**RESPONSE TO RURAL FIRE SERVICE QUERIES
ON THE
PROPOSED RESIDENTIAL FLAT COMPLEX
ON LOT 25 and LOT 26 in DP 228850,
No. 164 - 170 CROATIA AVENUE,
EDMONDSON PARK**

**RESPONSE TO THE NSW RURAL FIRE SERVICE
QUERIES**

Report Number	Document	Preparation Date	Issue Date	Directors Approval
B203519 - 2	Final	07.09.2020	17.06.2021	<i>G.L.Swain</i>

This response has been prepared to address the matters raised by the NSW Rural Fire Service and the letter dated 12th May 2021 (Reference DA20210217000617-Original-1).

Figure (i) Concept design for the Maxwells Creek riparian corridor.

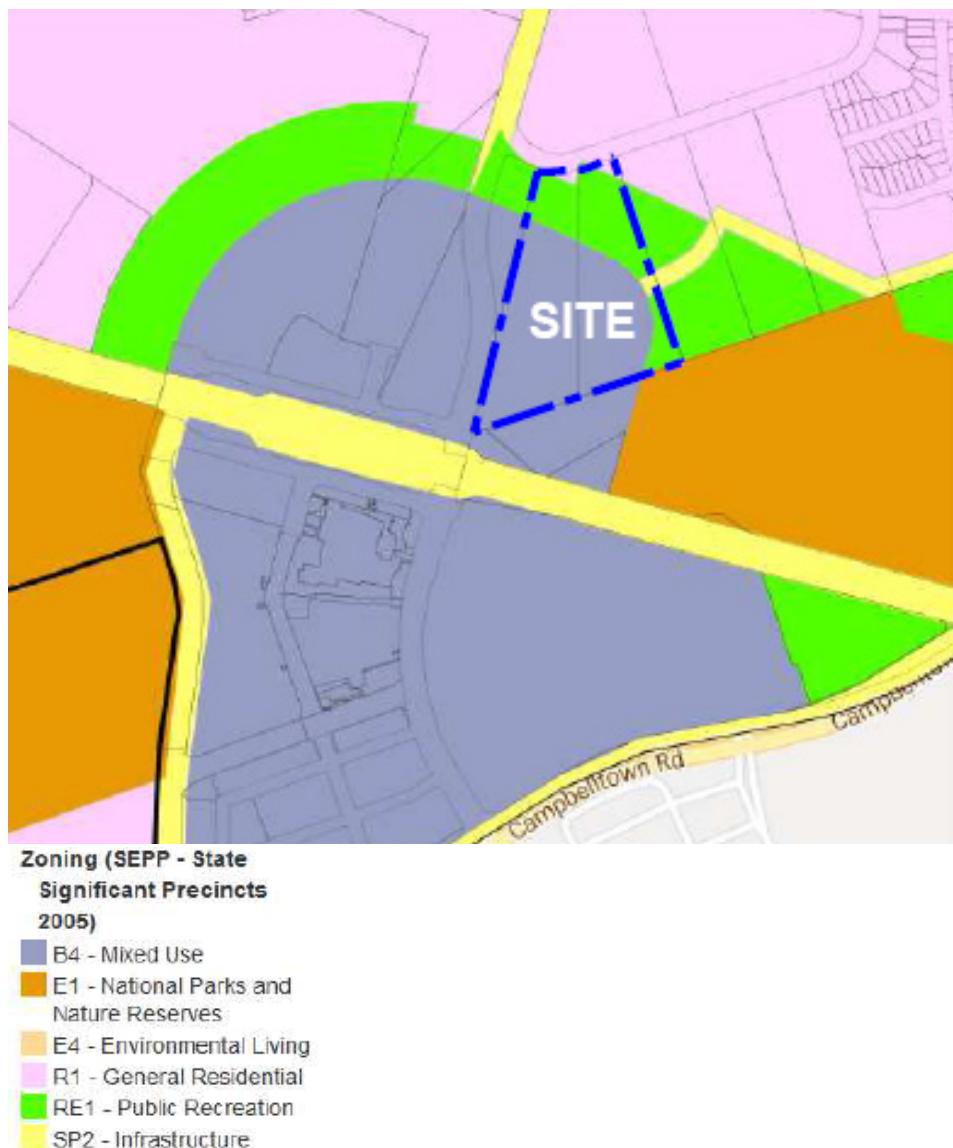
1. Both the statement of environmental effects and bushfire assessment report reference the works to the riparian area that traverses and adjoins the site. The NSW RFS requires full details of these proposed works in order to determine the nature of the future bushfire hazard and therefore the acceptability or otherwise of the development. The following specific details are required:

- plan to scale showing the extent of works, including re-aligned creek
- vegetation to be retained
- details of planting to be undertaken, including indicative species, numbers and/or planting density
- vegetation management plan if any
- future landform/topography in order to calculate relevant slopes.

Figure (i) on Page 4 is a concept design for the Maxwells Creek riparian corridor, prepared by Storm Consulting for Liverpool City Council. The plan details the location of the Bioretention Basins, creek banks, embankments and vegetated overbank.

The Bioretention basins are proposed to be planted with Macrophytes or similar low bushfire hazard reed planting.

Whilst not noted on the Concept Plan, the vegetated overbank area (light green) is likely to contain Cumberland Plain Woodland vegetation. The maximum width of this revegetated area is 40 metres.

Figure (i) provides detailed measurements and gradients of the reformed Maxwells Creek corridor.

Figure (iii) – Contour Plan (prepared by Registered Surveyor)

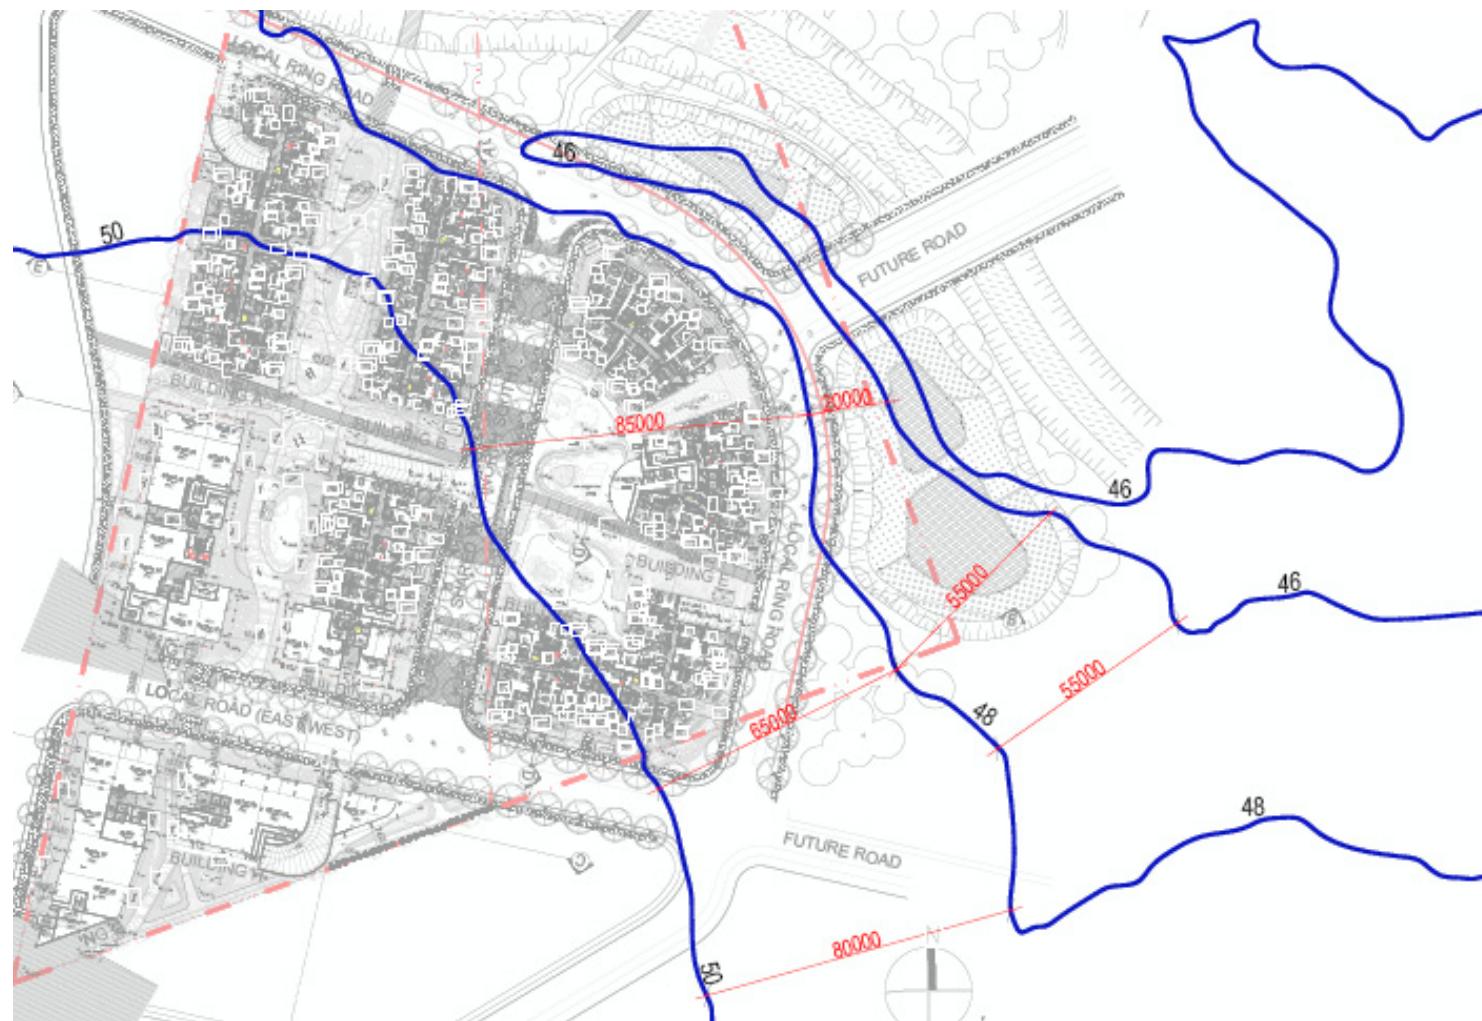
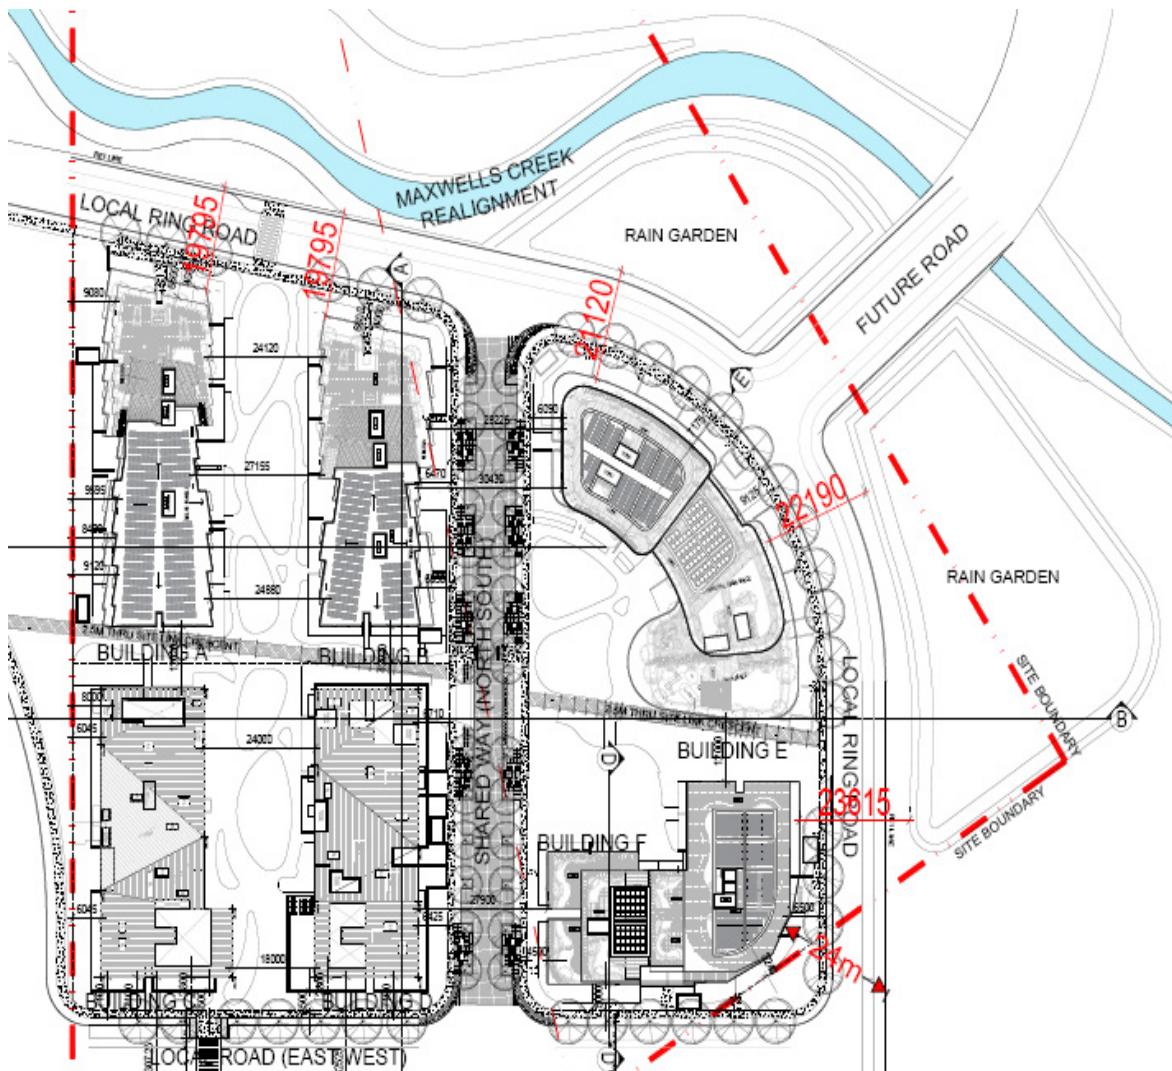
Note that as it stands the RFS has assessed slopes generally to the east as within the range of 0-5 degrees, which affects the necessary Asset Protection Zones. This does not agree with the assessment in the report by Australian Bushfire Protection Planners.

6. In relation to building F, the RFS has assessed that a 29m APZ is required on the eastern aspect. This does not agree with the assessment in the report by Australian Bushfire Protection Planners. The difference comes about due to our assessment of the worst case slope being on a due east aspect within the range 0-5 degrees. It has also been calculated that only a 20m APZ is available. Subject to details being provided as per point 2 above, redesign would be required to achieve the 29m APZ.

The R1 zoned land to the east of the creek corridor is level – refer to Figure (iii) – Contour Plan (prepared by Registered Surveyor) on Page 7.

The surveyed levels shown in Figure (iii) confirm that the information provided in the ABPP Bushfire Protection Assessment Report are correct – i.e. level and upslope to the southeast and south.

The width of the 24 metre wide Asset Protection Zone recommended in the ABPP report for forest vegetation (within the proposed National Park) with an effective slope of level/upslope is correct.

Figure (iv) - Detailed measurements of the proposed Asset Protection Zones to the buildings.

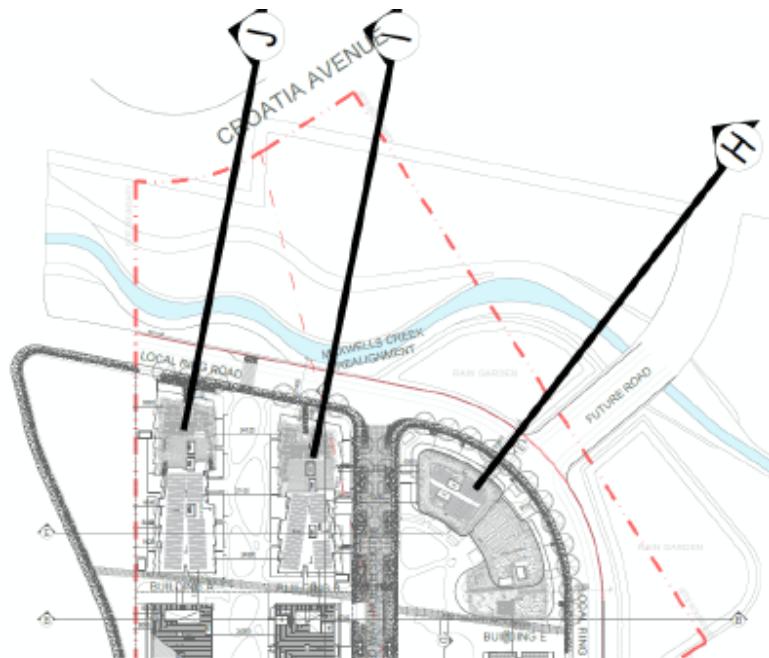
2. A site plan that indicates both setback distances of buildings to roads and road widths, to enable an accurate calculation of the proposed asset protection zones/separation distances to future bushfire hazards.

Figure (iv) on Page 8 provides detailed measurements of the proposed Asset Protection Zones to the buildings.

The widths of Asset Protection Zones shown do not include the availability of the low hazard vegetation in the riparian corridor.

Figure (vi) - Detailed Section 'H' of Perimeter Road.

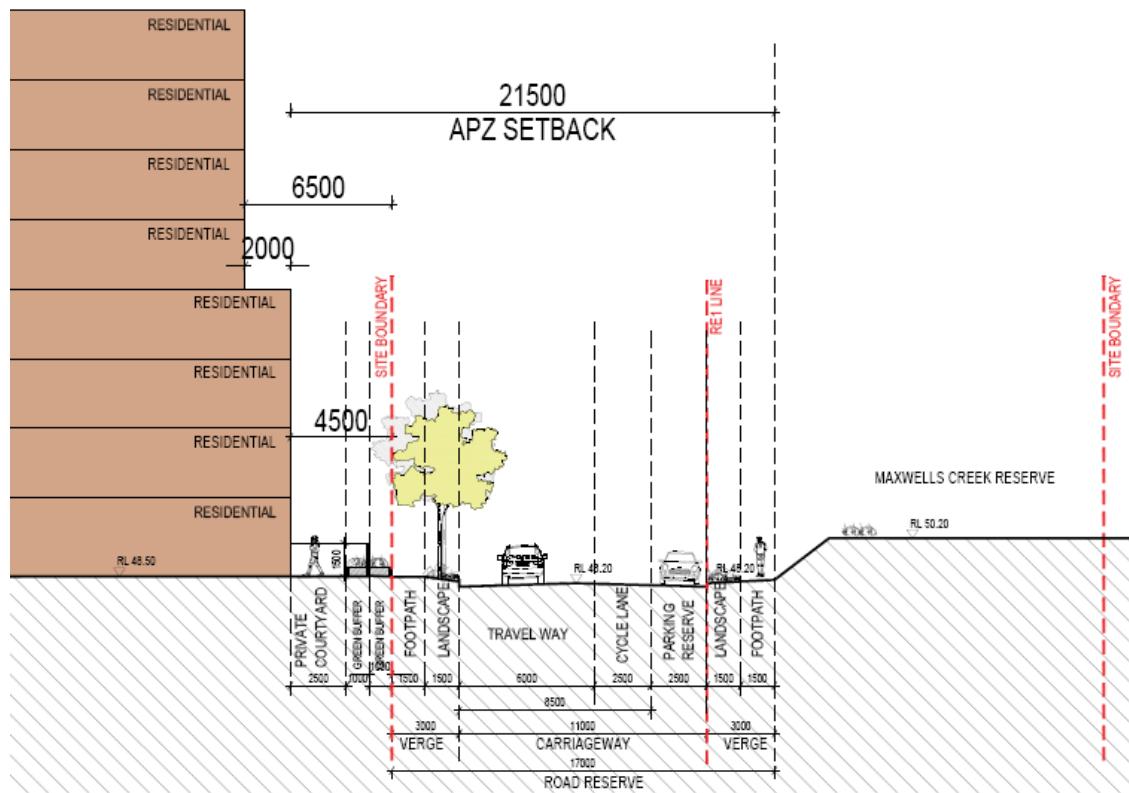
3. Amendment to the width of the proposed local ring road. This road will serve as a perimeter road and as per section 5.3.2 of *Planning for Bush Fire Protection 2019*, must have a minimum carriageway width of 8m, with parking provided outside of the carriageway width.

Figures (vi), (vii) & Figure (viii) on Pages 9, 10 & 11 provide detailed sections through the perimeter road, confirming that the overall width of the perimeter road is 8.0 metres – kerb to kerb with parking provided beyond the road pavement width.
